# PREVOST

## WARRANTY BULLETIN

**WB24-39**

DATE :	November 2024	SECTION :	06 ELECTRICAL
EXPIRATION:	November 2026		
SUBJECT :	FUSE F130 REPLACEMENT

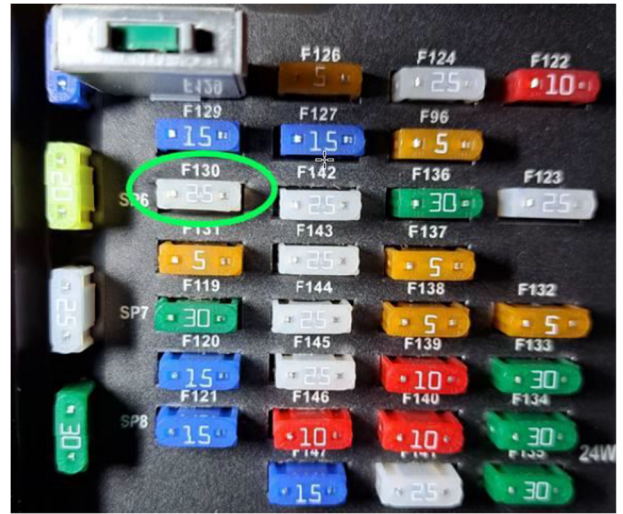
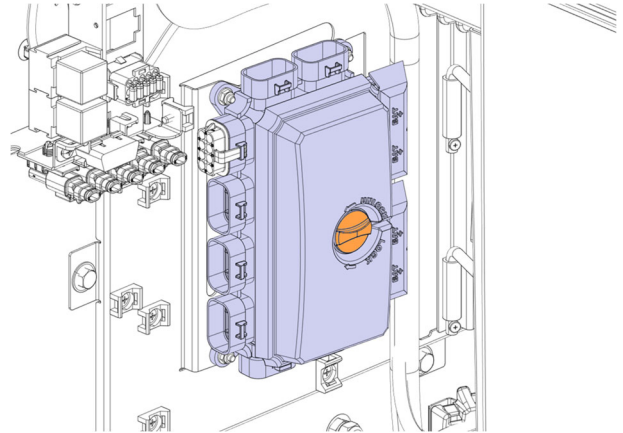
4. Check fuse F130:

- If it is a 25A fuse, no action is required.
- If it is not a 25A fuse, carefully remove it using needle nose pliers, then, install new fuse **563153**.
